**SERVICE BULLETIN**

SB No. 039

**TITLE** INSPECTION OF WING REAR SPAR TOP SURFACE TO FUSELAGE FAIRING CLEARANCE**CLASSIFICATION** This Service Bulletin has been classified as optional by the U.K. Civil Aviation Authority.**COMPLIANCE** Within the next 150 flying hours, or 3 months from date of this Service Bulletin, whichever is earlier.**APPLICABILITY:**

All T67 GRP Series Aircraft, except Works Nos. 2074, 2077, 2081-2083, 2087, 2099-2101.

FIGURE 1

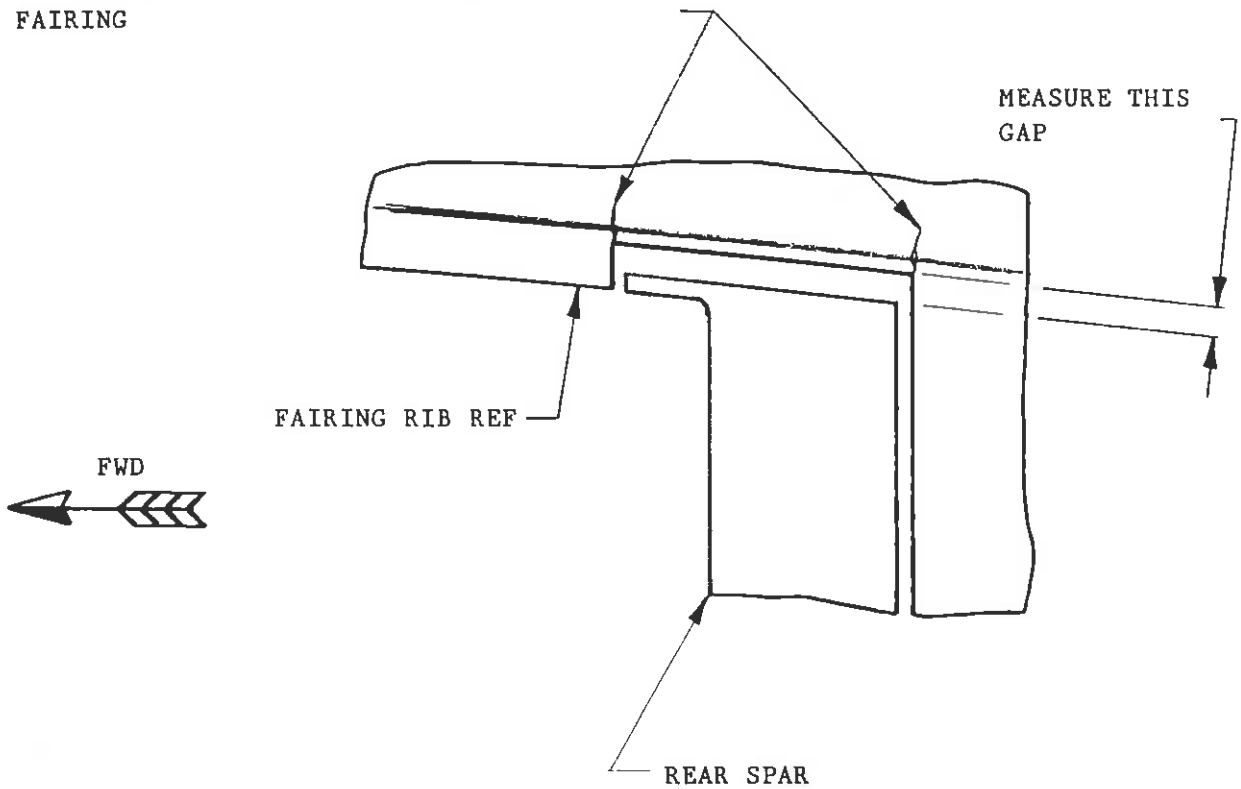
A case has occurred whereby the clearance between the wing rear spar top surface and the fuselage fairing has been insufficient to prevent contact at high positive load factors. This has resulted in cracking of the fuselage fairing which, although not structurally significant, is undesirable.

1. Inspect the fuselage fairing for cracking adjacent to the wing rear spar.
2. Measure and record the minimum clearance between the wing rear spar top surface and the fuselage fairing. (Port and starboard) (See Figure 1).
3. Pass details of 1, and 2, above to Slingsby Aviation Ltd.

POSSIBLE AREAS OF CRACKING IN FUSELAGE FAIRING

Rectification action, if required, will be agreed between Slingsby Aviation Ltd and the Customer.
